Contract #: 04-0120F4Cty: SF/ALA Rte: 80 PM: 13.2/13.9File #: 69.25B**QUALITY ASSURANCE -- NON-CONFORMANCE REPORT****Location:** Changxing Island, Shanghai, P.R. China**Report No:** NCR-000713**Prime Contractor:** American Bridge/Fluor Enterprises, a JV**Date:** 21-Apr-2010**Submitting Contractor:** Zhenhua Port Machinery Company, Ltd (ZPMC), Changxing Island**NCR #:** ZPMC-0680**Type of problem:**

Reference Description: Heat straightening utilizing excessive heat and performing the work with no written procedure to show QA and QC on Floorbeam FB3014-001

Job Name: SAS Superstructure

Subject: NCR No. ZPMC-0680

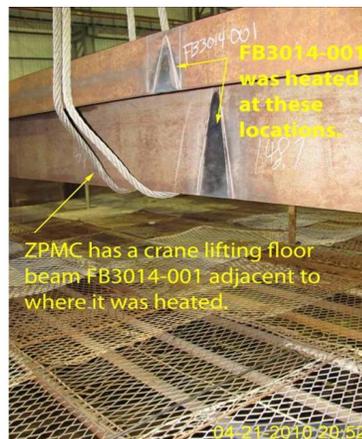
During random in process observations of OBG segment 12CE in Bay 14, this Caltrans Quality Assurance (QA) Inspector observed the following issues:

- Heat straightening was performed on Floorbeam FB3014-001 without an approved heat straightening document.
- ZPMC had a crane lifting upward with an unknown amount of uplifting force on the Floorbeam while heat straightening the Floorbeam base metal to a bright cherry-red color.

- The AWS D1.5 Section 3.7.3 states that the heated steel shall not exceed 650°C, which gives a dull red color.
- ZPMC QC Certified Welding Inspector (CWI) Geng Wei and the ABF representative Yang Chao were not aware that this heat straightening was taking place.

- ZPMC CWI did not know if a heat straightening document had been submitted for this activity, and no document was issued to record this activity had taken place.

- A temp stick, digital temperature measurement gauge, or other similar means of monitoring the heat input was not utilized by ZPMC personnel and the actual maximum attained temperature was not measured.

- Floorbeam FB3014-001 is welded in place at OBG segment 12CE near panel point PP115.5.

Please provide HSR and documentations that demonstrate the over-heated element is acceptable. Propose a resolution for the identified non-conformance to prevent future occurrences. A response for the resolution of this issue is expected within 14 days.

Reference Description: Heat straightening utilizing excessive heat and performing the work with no written procedure to show QA and QC on Floorbeam FB3014-001

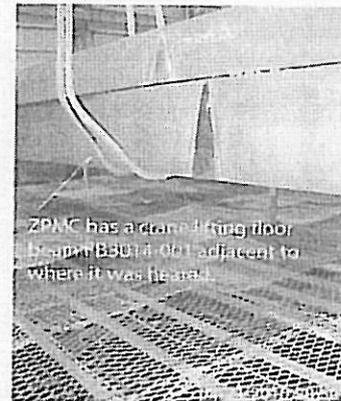
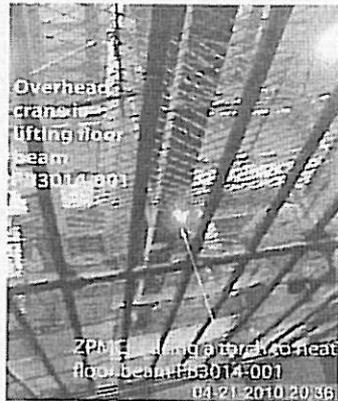
During random in process observations of OBG segment 12CE in Bay 14, this Caltrans Quality Assurance (QA) Inspector observed the following issues:

- Heat straightening was performed on Floorbeam FB3014-001 without an approved heat straightening document.
- ZPMC had a crane lifting upward with an unknown amount of uplifting force on the Floorbeam while heat straightening the Floorbeam base metal to a bright cherry-red color.

- The AWS D1.5 Section 3.7.3 states that the heated steel shall not exceed 650°C, which gives a dull red color.
- ZPMC QC Certified Welding Inspector (CWI) Geng Wei and the ABF representative Yang Chao were not aware that this heat straightening was taking place.

- ZPMC CWI did not know if a heat straightening document had been submitted for this activity, and no document was issued to record this activity had taken place.

- A temp stick, digital temperature measurement gauge, or other similar means of monitoring the heat input was not utilized by ZPMC personnel and the actual maximum attained temperature was not measured.

- Floorbeam FB3014-001 is welded in place at OBG segment 12CE near panel point PP115.5.

Heat Straightening Record(HSR1)

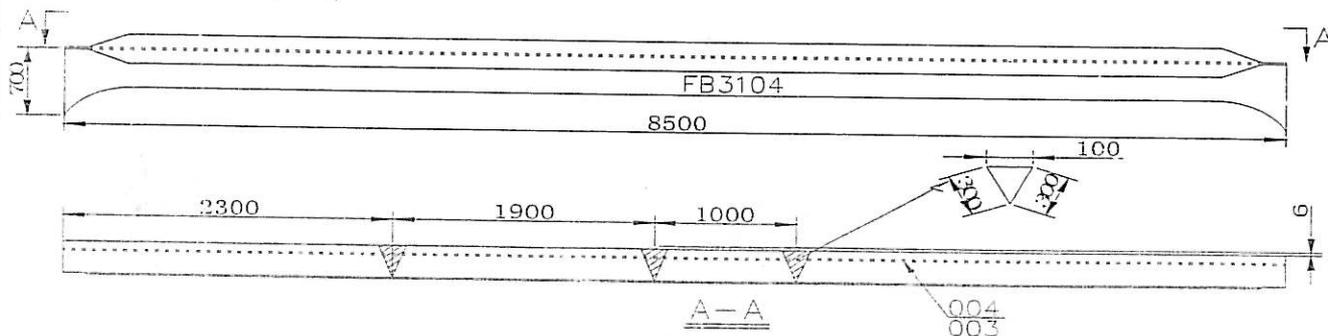
After finishing heat straightening, the weld of the heat area shall perform NDT according to the approved shop drawing 校火后, 根据图纸要求对热影响区域进行NDT检测。

Control current, voltage and weld speed according to relevant WPS. If necessary anti-deformation or hold down device can be added. 依据相应的WPS的要求控制电流, 电压和焊接速度。如有必要, 可使用反变形设施进行校正。

Reference Description: Excessive heat was utilized during heat straightening of the traveler rail 11TR2-007

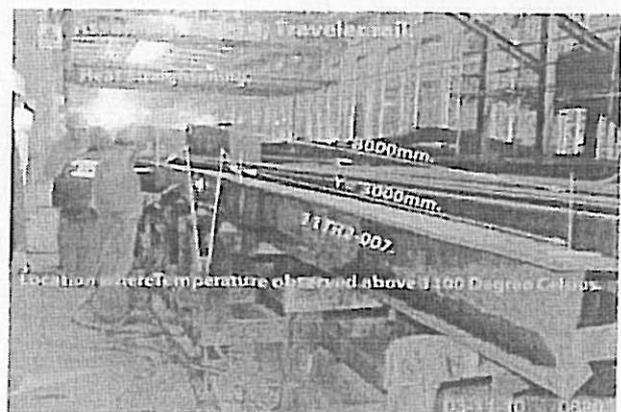
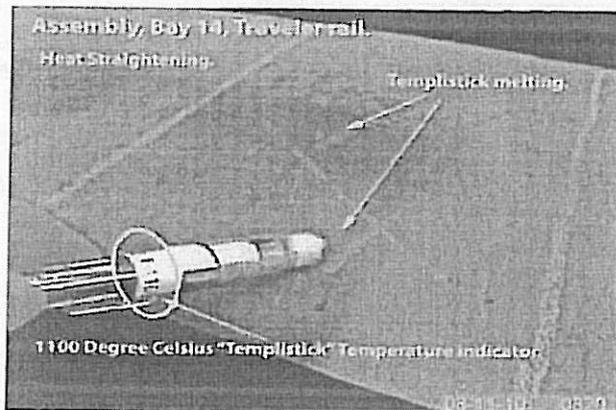
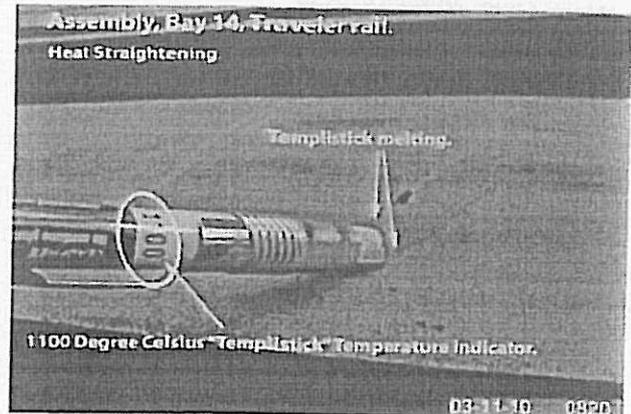
During the Quality Assurance (QA) random in-process visual inspection of OBG traveler rail Heat Straightening, this QA Inspector observed the following:

- Temperature of the heat straightened traveler rail was beyond the allowable 650 Degree Celsius in two locations.
- Per ZPMC heat straightening report (HSR) maximum temperature limit is 650 Degree Celsius.
- The 1100 Degree Celsius rating "templstick" was melted when check was made against the metal surface.
- "Y" location of the spots identified as 3000mm & 8000mm at the flange.
- The Traveler Rail is identified as 11TR2-007.

Propose a resolution for the identified non-conformance with revised procedures to prevent future occurrences. A response for the resolution of this issue is expected within 7 days.

Reference Description: Excessive heat was utilized during heat straightening of the traveler rail 10TR3-022

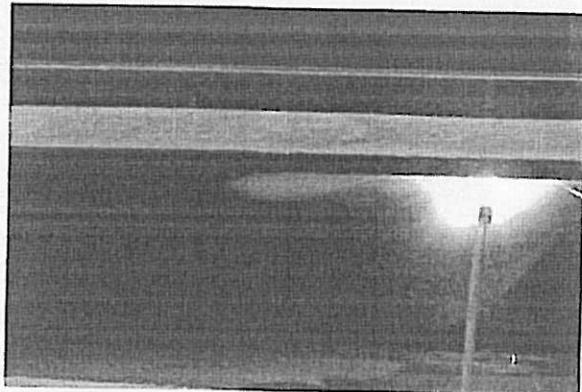
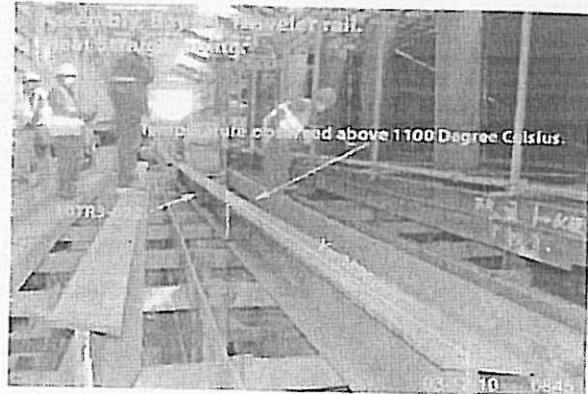
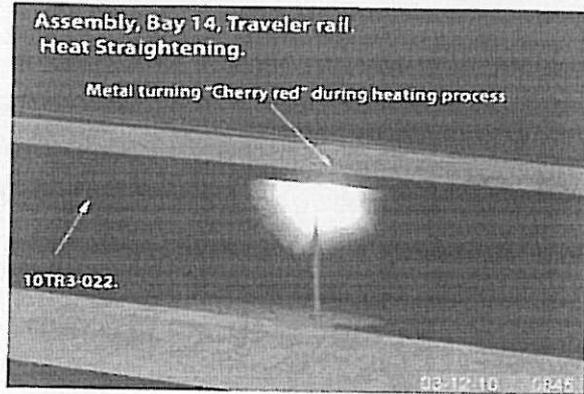
During the Quality Assurance (QA) random in-process visual inspection of OBG traveler rail Heat Straightening, this QA Inspector observed the following:

- Temperature of the heat straightened traveler rail was beyond the allowable 650 Degree Celsius.
- Metal color turns into "cherry red" after it was heat straightened.
- Per ZPMC heat straightening report (HSR) maximum temperature limit is 650 Degree Celsius.
- The 1100 Degree Celsius rating "templstick" was melted when check was made against the metal surface.
- "Y" location of the spot identified was 3890 mm and it is at the flange to web joint.
- The Traveler Rail is identified as 10TR3-022.

Propose a resolution for the identified non-conformance with revised procedures to prevent future occurrences. A response for the resolution of this issue is expected within 7 days.

Reference Description: Heat straightening utilizing excessive heat and performing the work with no written procedure to show QA and QC on Floorbeam FB3014-001

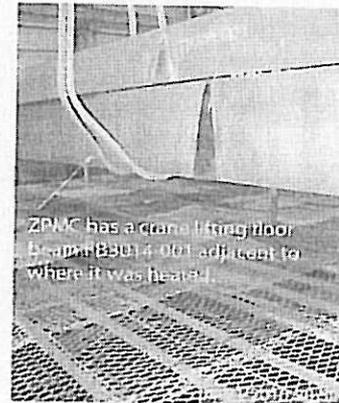
During random in process observations of OBG segment 12CE in Bay 14, this Caltrans Quality Assurance (QA) Inspector observed the following issues:

Reference Description: Excessive heat was utilized during heat straightening of the traveler rail 10TR3-022

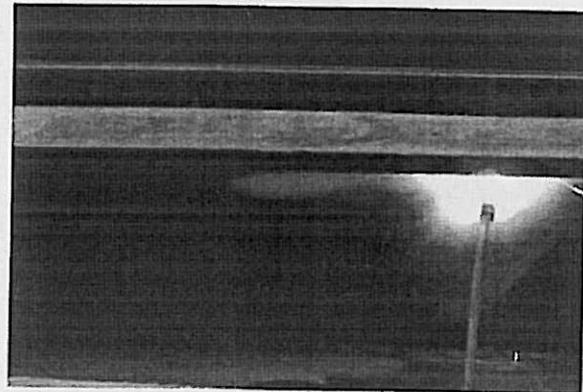
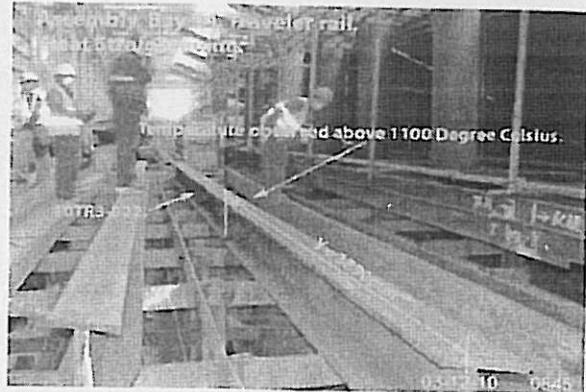
- Temperature of the heat straightened traveler rail was beyond the allowable 650 Degree Celsius.
- Metal color turns into "cherry red" after it was heat straightened.
- Per ZPMC heat straightening report (HSR) maximum temperature limit is 650 Degree Celsius.
- The 1100 Degree Celsius rating "templstick" was melted when check was made against the metal surface.
- "Y" location of the spot identified was 3890 mm and it is at the flange to web joint.
- The Traveler Rail is identified as 10TR3-022.

Reference Description: Heat straightening utilizing excessive heat and performing the work with no written procedure to show QA and QC on Floorbeam FB3014-001

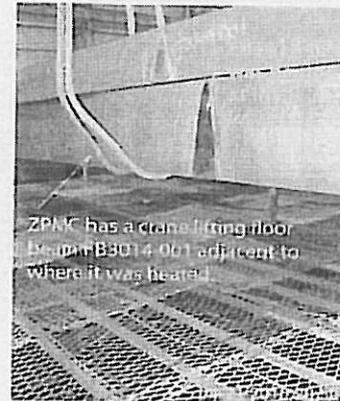
During random in process observations of OBG segment 12CE in Bay 14, this Caltrans Quality Assurance (QA) Inspector observed the following issues:

Reference Description: Excessive heat was utilized during heat straightening of the traveler rail bracket TR6A-052; QC allowed heat straightening to be performed without a temperature measuring device

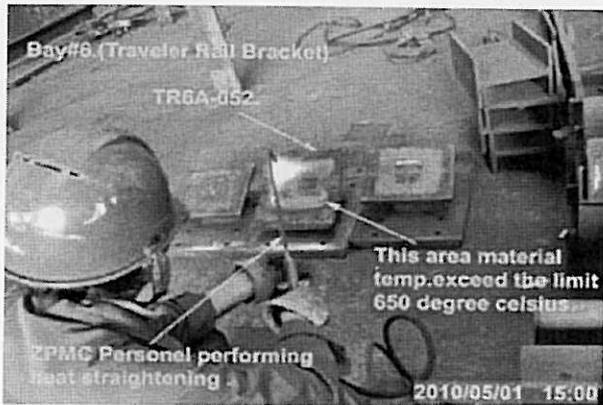
During the Quality Assurance (QA) random in-process observations of the fabrication of OBG Traveler Rail (TR) brackets, this Caltrans QA Inspector observed the following:

Perform hardness testing over area in question.

Contractor submitted results of hardness testing performed on the area in question. After review, the Department has found the results to be acceptable. ZPMC also issued an internal NCR in regards to this issue.
